Planning and Development Services Division Public Hearing Summary Report

P.Z. 09-2013 Schoettler Grove (2349 Schoettler Rd.): A request for a zoning map amendment from “NU” Non-Urban District (3 acre) to “R-3” Residence (10,000 sqft lot min.) for 17.0 acres located northwest of the intersection of Clayton Rd. and Schoettler Rd. (20R310137 & 20R220010).

P.Z. 10-2013 Schoettler Grove (2349 Schoettler Rd.): A request for a zoning map amendment from “R-3” Residence District (10,000 sqft lot min.) to “PUD” Planned Unit Development for 17.0 acres located northwest of the intersection of Clayton Rd. and Schoettler Rd. (20R310137 & 20R220010).

Public Hearing Report
August 12, 2013

PRELIMINARY SITE PLAN

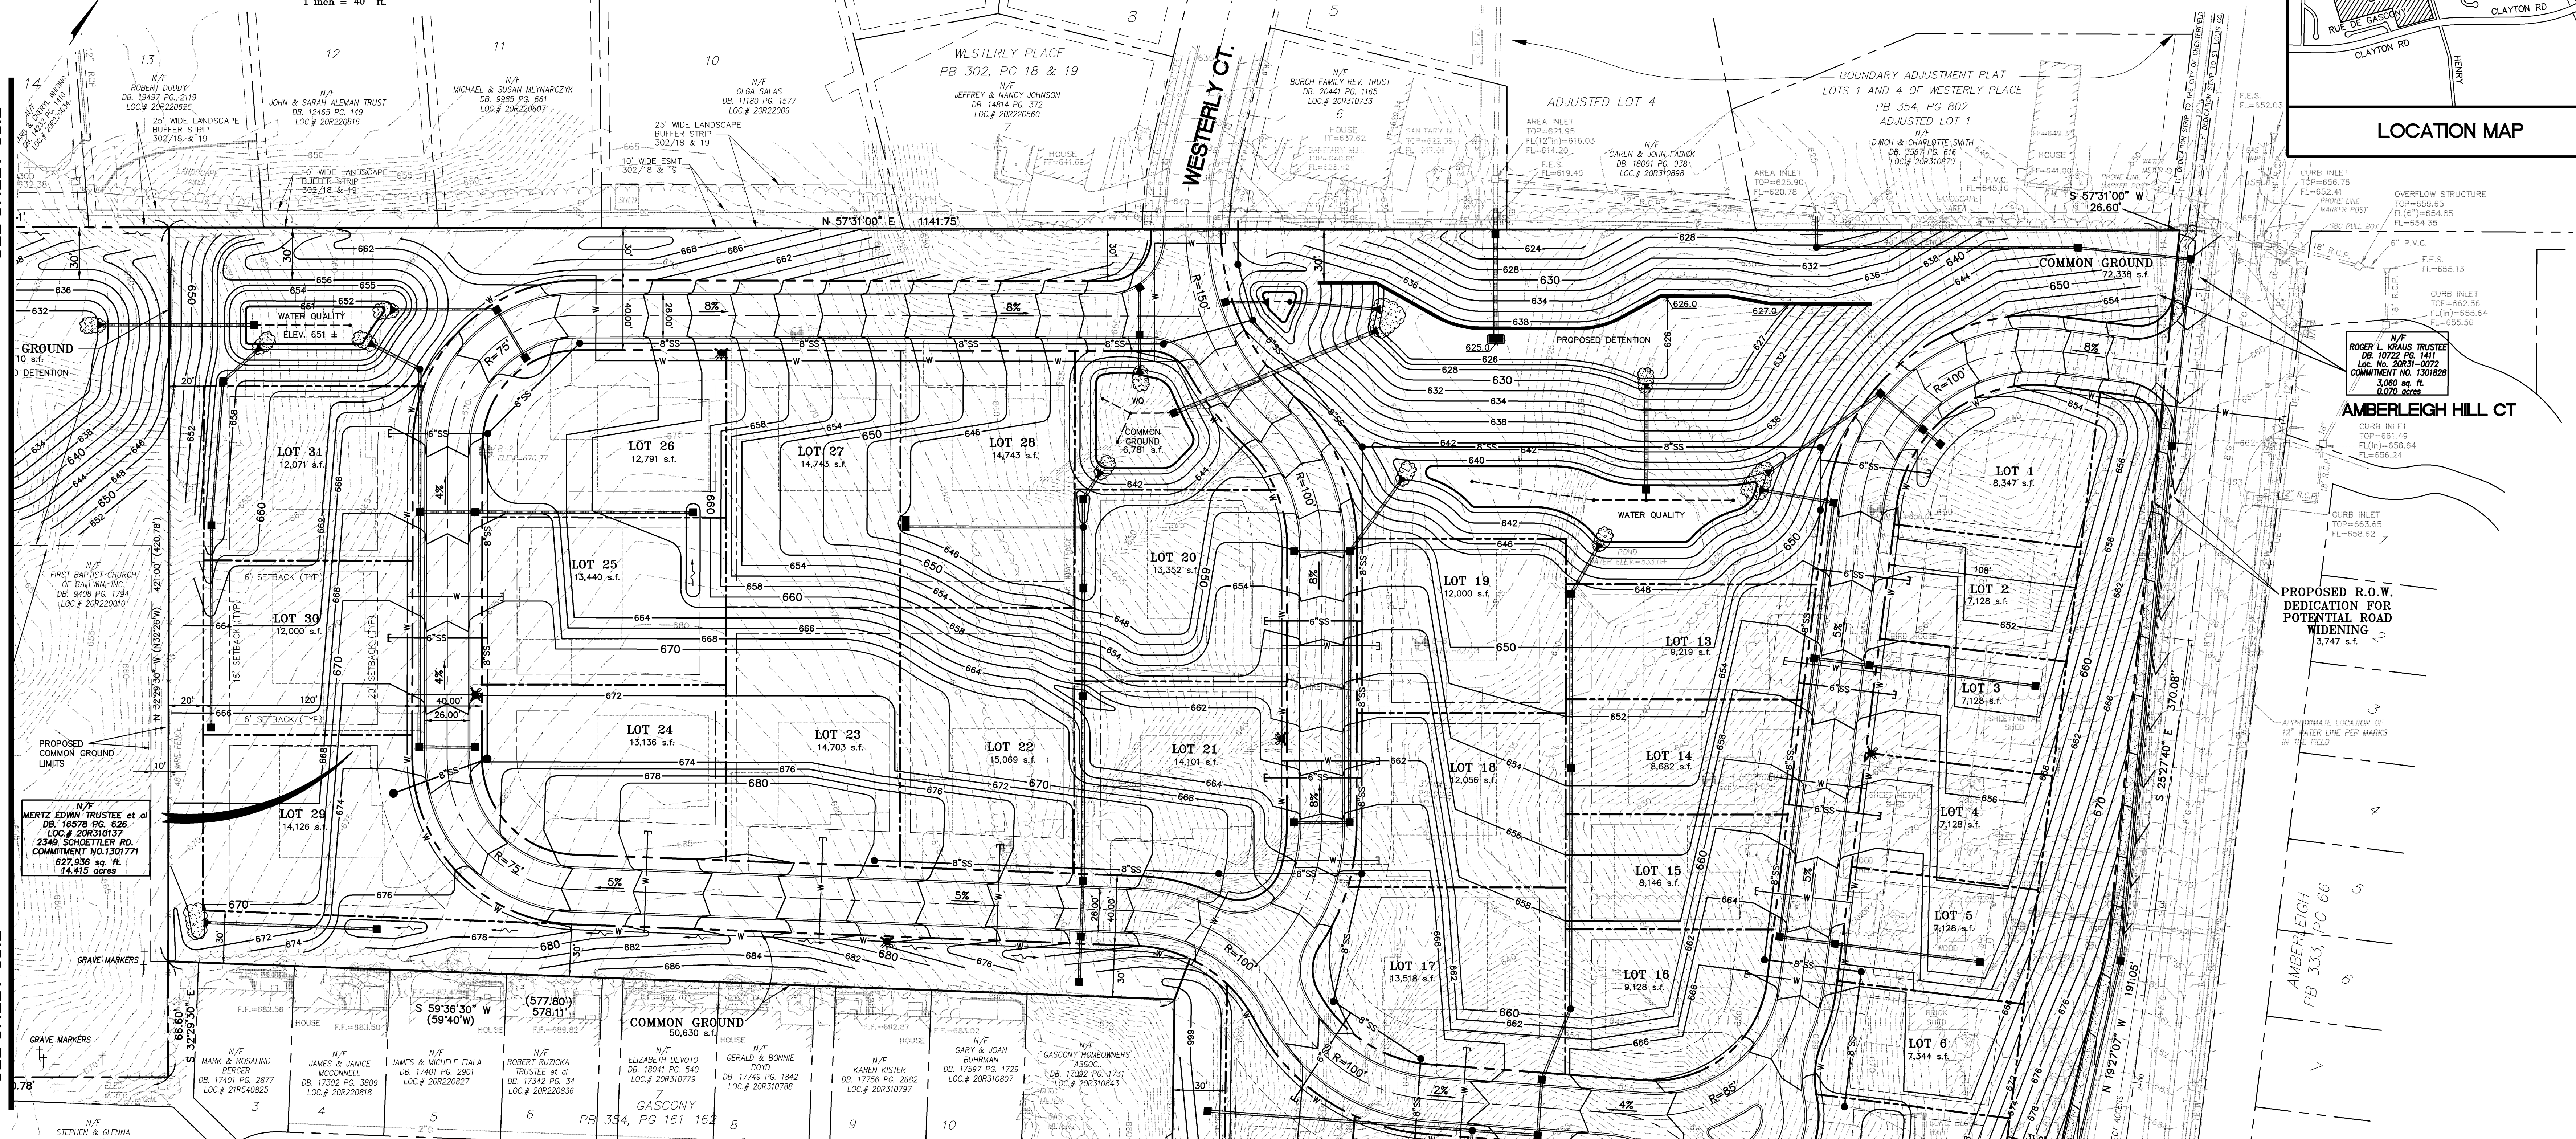
Thank you for meeting with Nan Johnson and I to review the plans for the development of Schoettler Grove. After meeting and reviewing the proposed development with you, the developers and our councilman, we have several items which we would encourage the City of Chesterfield to carefully review before granting approval to this project. As homeowners of the Westerly Court subdivision immediately adjacent to the Mertz property, we are concerned about the following:

- **Storm water drainage** – Currently, there is a lot of water that drains into the storm water drain at the southeast end of our property. Several of the yards in the neighborhood have areas that are wet and boggy. There is a concern that the change in the topography could exacerbate an already less than ideal situation.

- **Buffer between Schoettler Grove and Westerly Place** –It is our understanding the developer plans a 30' buffer between our subdivision and Schoettler Grove. We would like to see a buffer of at least 30' and heavily landscaped with trees and plants. The landscaping would provide a private divider between neighboring subdivisions consistent with what we now have between Westerly Place and Georgetown. But more importantly, the dense, heavy landscaping would help to diffuse the noise and light from Clayton Road and the surrounding area allowing not only us to maintain a lifestyle consistent with what we currently have but also our future neighbors.

- **Continuance of Westerly Court into Schoettler Grove** – The proposed development outlines the extension of Westerly Court into the Schoettler Grove subdivision. The developers have assured Westerly Place homeowners they are neutral on access to their development through our subdivision. As a result of the extension of Westerly Place, the homeowners in both subdivisions will be faced with increased traffic, increased noise and the potential for more accidents due to more traffic. This connection between the two subdivisions is not consistent with maintaining distinct private neighborhoods like we see in the neighboring subdivisions on Schoettler. We have been told it is desirable to have two entries into a subdivision in the event emergency

As to the proposed development itself, it does little to buffer the existing residential properties from subdivision vehicle traffic. The 30 ft. proposed buffer on the south side of the development which borders the Gascony subdivision will not provide a sufficient buffer to the street that serves the development. Vehicle headlights will shine into the living areas of the Gascony residences even though there is some drop off in elevation to the proposed street from the rear of those residences. Interestingly, the proposed development has a much larger buffer along Clayton and Schoettler Roads and is recognition by the developer that a 30 foot buffer is inadequate to ameliorate vehicle light and noise pollution.

Second, we believe our subdivision should be separated from Schoettler Grove similar to the buffer created between Westerly Place and Georgetown to our north. Georgetown was able to secure a solid strip of green space between their subdivision and Westerly Place when it was developed. Instead of trying to salvage a few trees along our property line we would like to request the construction of a heavily landscaped berm which extends ten feet above the level of the road in the proposal and extends along the length of the north edge of the proposed Schoettler Grove. This would help to abate the increased noise and light pollution from Clayton Rd and Schoettler Grove when the existing protective green canopy disappears and would lessen the negative impact of a new development on our subdivision. Also, it should be noted that a variance was granted to the home builder for lots #6 and #7 in Westerly Court. These driveways were placed on the lot line of the Mertz property. Therefore, a 30' buffer is not an adequate zone of separation between the two subdivisions.
